81-83 Grange Road, Tuffley

Technical Note TN002 – Surface Water Drainage
July 2022

2 Gloucester City Council Drainage Officer comments – 30th June 2022

TITLE:
Surface Water Drainage Strategy

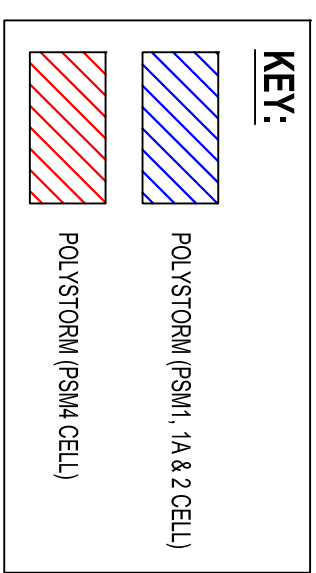
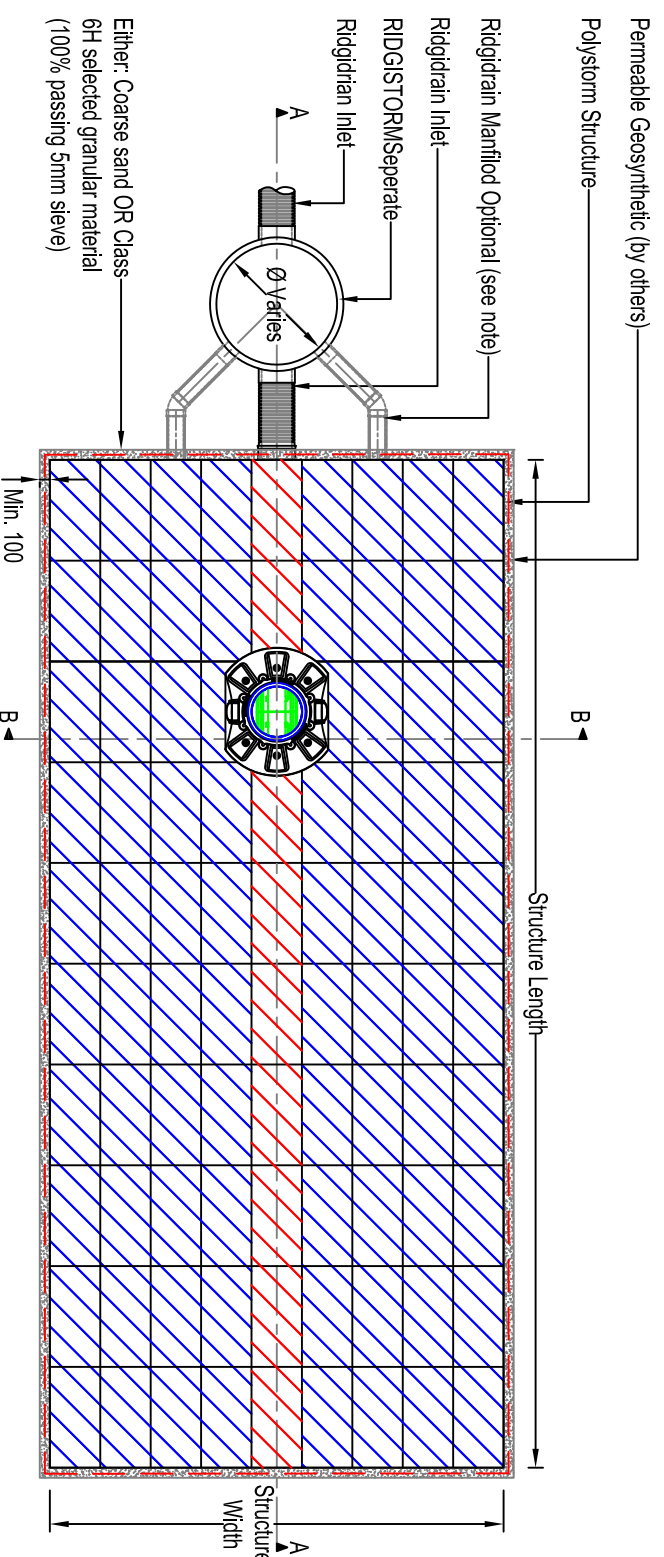
- *Confirm contributing areas - there is a significant discrepancy to that submitted before - can this be presented in a labelled drawing.*
- *Soakaway tests appears to be fine.*
- *Given the proximity of adjacent properties - the infiltration through the base of the crates would the fill mechanism of the two systems here are different. Similarly this needs to be at least 5m from any building/ foundations.*
- *Confirmation of the size of the porous pavement is required (a plan) and should exclude the area designated for the roof.*
- *Maintenance access / silt-trap for crates needs to be considered.*
- *No details of porous surfacing - what type is proposed.*
- *No details of crate surround.*

3.1 Refer to **Appendix A** for impermeable catchment confirmation. All roof areas contributing to positive drainage with all other areas discharging to ground/permeable access areas.

3.4 Refer to **Appendix A** for 5m offset identified. No structures within 5m from proposed soakaway.
